**Subject: Proposed Amendments to the Technical Rules Submitted by  
Western Power (March and April 2016)**

### **Follow up – March 2016 – Three phase credible contingency faults**

FIGURE 8.2. DIAGRAM TO DETERMINE THE SHORT-CIRCUIT TYPE FOR GREATEST SHORT-CIRCUIT CURRENT WHEN THE PHASE ANGLES OF THE SEQUENCE IMPEDANCES ARE IDENTICAL

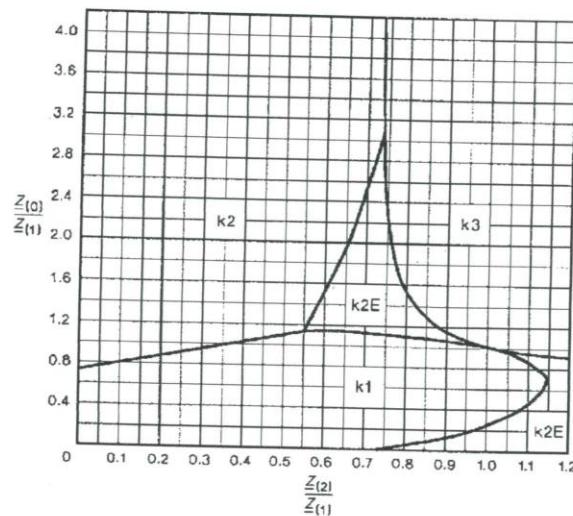
1. I disagree with the statement "*we do not consider safety to be relevant*", p.7 of the ERA (technical consultant's report). Namely, safety is paramount in all we do and the proposed change to remove three phase faults from the list of credible contingencies, if accepted, would adversely affect it, because three phase faults are often the most critical from the perspective of equipment selection. For proof, refer to Figure 8.2(a), the shaded area marked "k3" of the AS-3851 Short Circuit Fault Calculation for AC Systems.
